11 STATE OF CALIFORNIA
12 REGIONAL WATER QUALITY CONTROL BOARD, LOS ANGELES REGION
13 AND
14 STATE WATER RESOURCES CONTROL BOARD

15 Petition of NRDC, Los Angeles Waterkeeper, and)
16 Heal the Bay, for Review by the California)
17 Regional Water Quality Control Board, Los)
18 Angeles Region, of the Regional Board Executive)
19 Officer's Action to Conditionally Approve Nine)
20 Watershed Management Programs Pursuant to the)
21 Los Angeles County Municipal Separate)
22 Stormwater National Pollutant Discharge)
23 Elimination System (NPDES) Permit, Order No.)
24 R4-2012-0175, NPDES Permit No. CAS004001;)

PETITION FOR REVIEW OF LOS
ANGELES REGIONAL WATER
QUALITY CONTROL BOARD
EXECUTIVE OFFICER'S ACTION
TO CONDITIONALLY APPROVE
NINE WMPs PURSUANT TO THE
L.A. COUNTY MS4 PERMIT

Figure A. Model predicted results for total loads of lead directly from the model output file

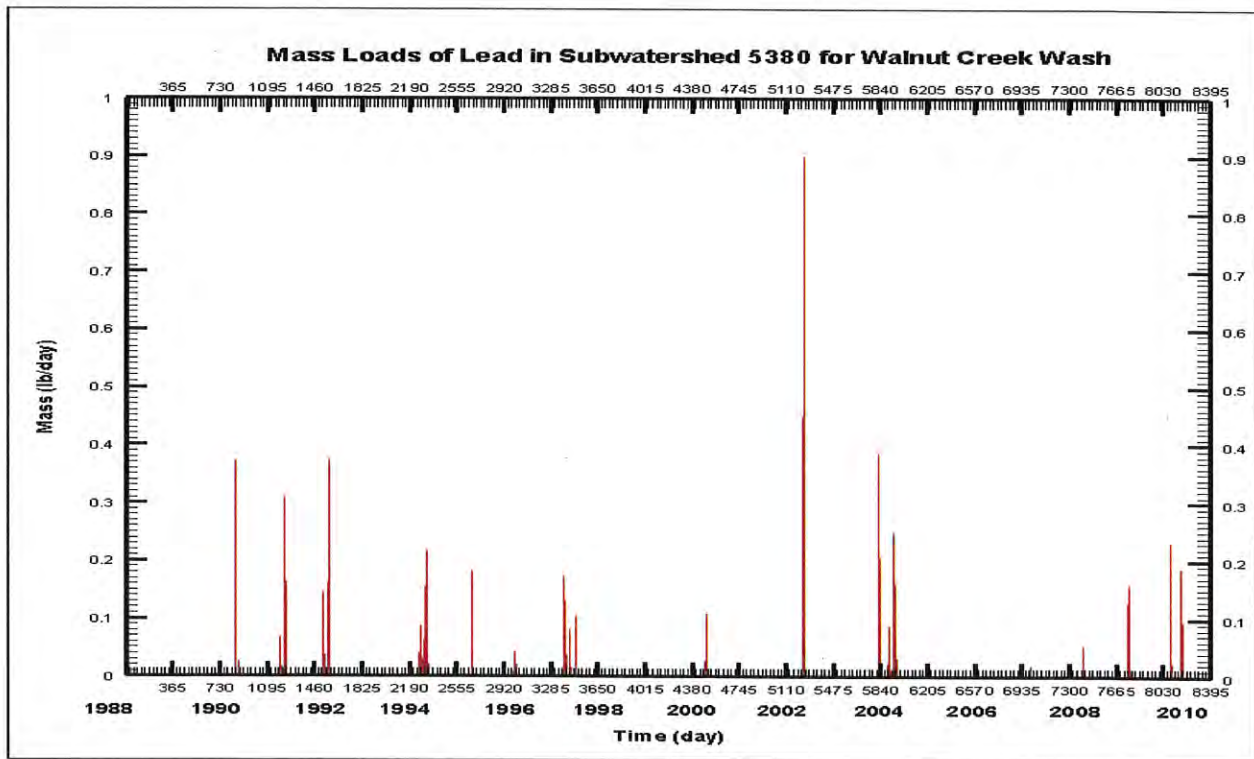
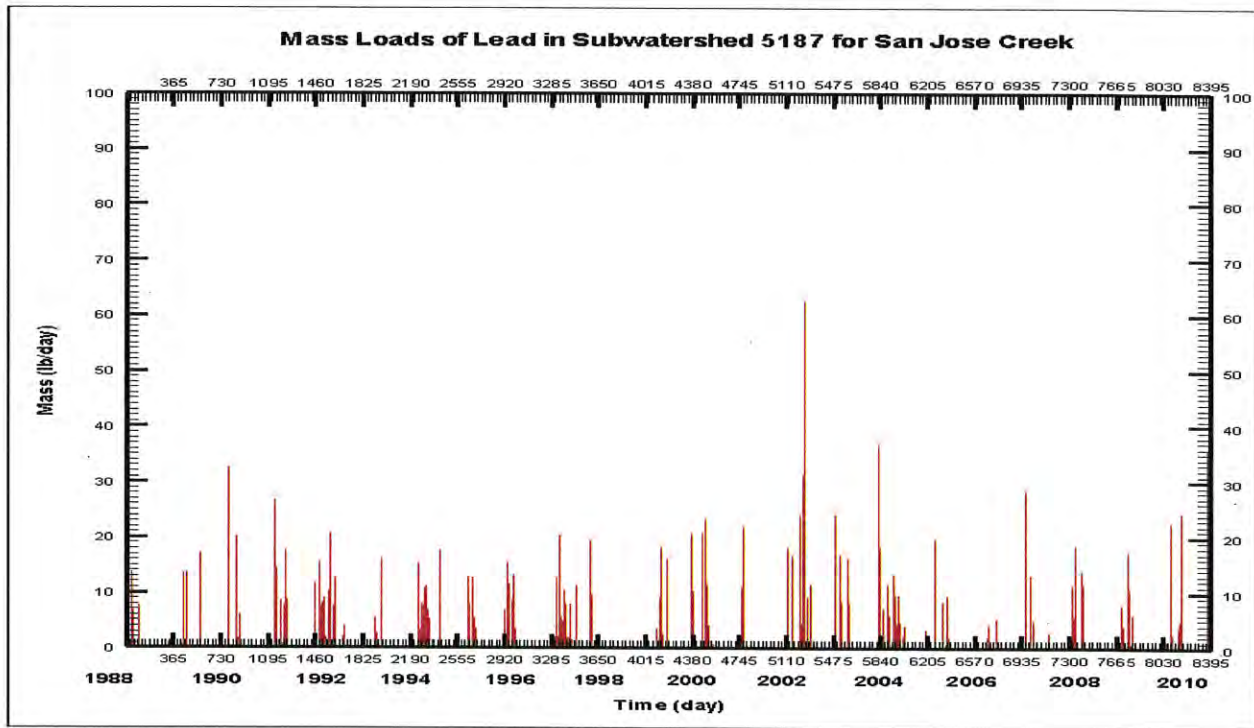
C. Modeling comments regarding lack of analysis for other Category 1 waterbody pollutant combination:

1. Model simulations, baseline loadings, and required reductions for selenium were not included in the Report.

Figure 1-8: Scatter Plot for LA River Copper

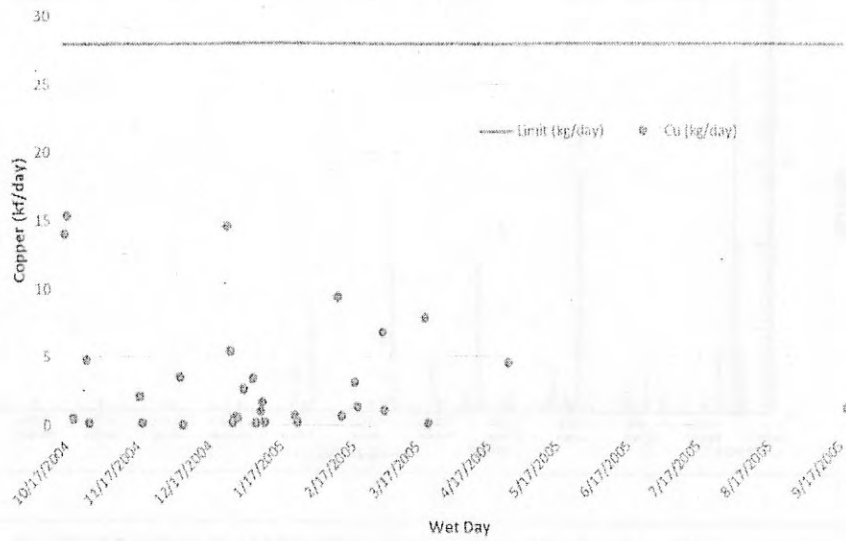
1. The model predicted mass contributions of pollutants from the City shown in Table 1-6 through Table 1-14 and Figure 1-8 through Figure 1-11 are not consistent with those values directly from the model output (see attached Figure A. and Figure B. for an example) . As such, the conclusion that no pollutant reduction is required should be re-evaluated.
